RX Family

LVD Module Firmware Integration Technology

R20TS0974ES0100
Rev.1.00
Nov. 01. 2023

Outline

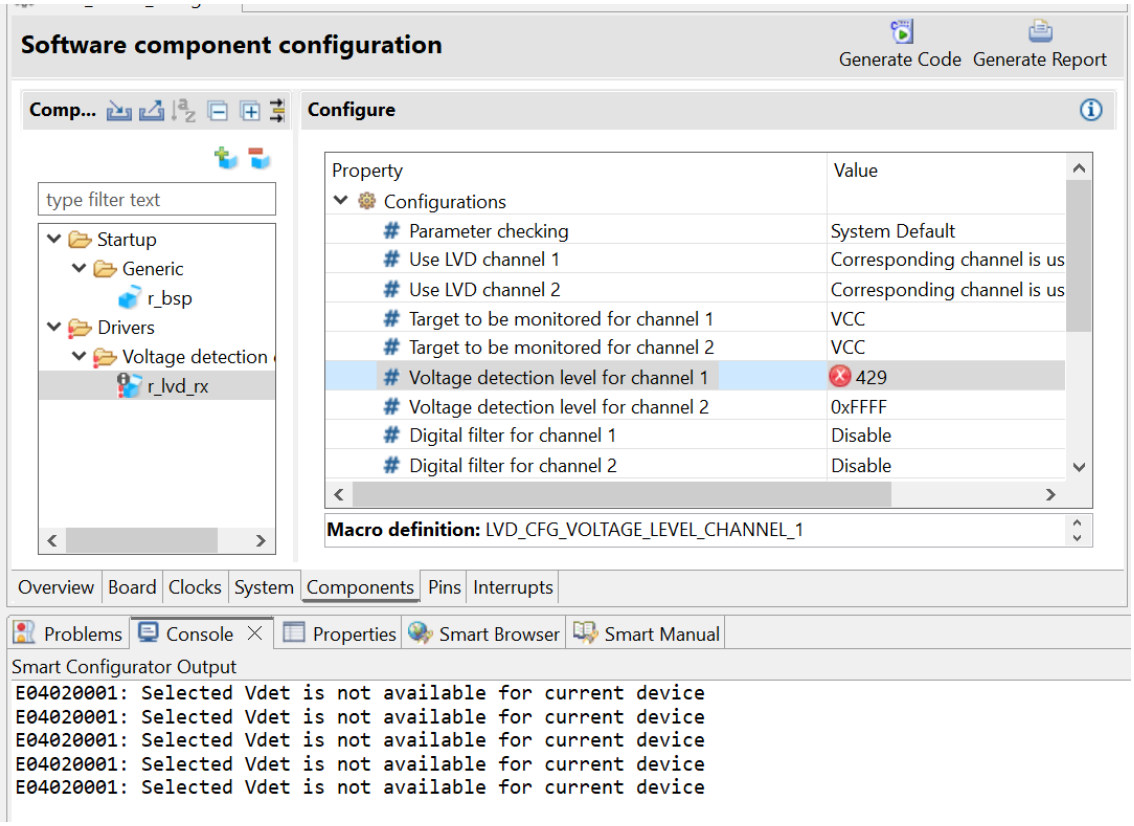
Setting “Voltage detection level for channel 1” and “Voltage detection level for channel 2” in Smart Configurator for RX23E-B would result in error

In LVD mdf file (r_lvd_rx_v4.50_extend.mdf), the “Voltage detection level” constraints for RX23E-B are missing. Therefore, when using Smart Configurator to set “Voltage detection level” either channel 1 or channel 2 for RX23E-B, the error “Selected Vdet is not available for current device” would occur

- When using Smart Configurator to set “Voltage detection level” (except default value) for RX23E-B.

Below is sample which illustrates the conditions under which the error would happen:

User should upgrade to LVD FIT Rev.4.60 once it is available.

This problem will be fixed in LVD FIT Rev.4.60
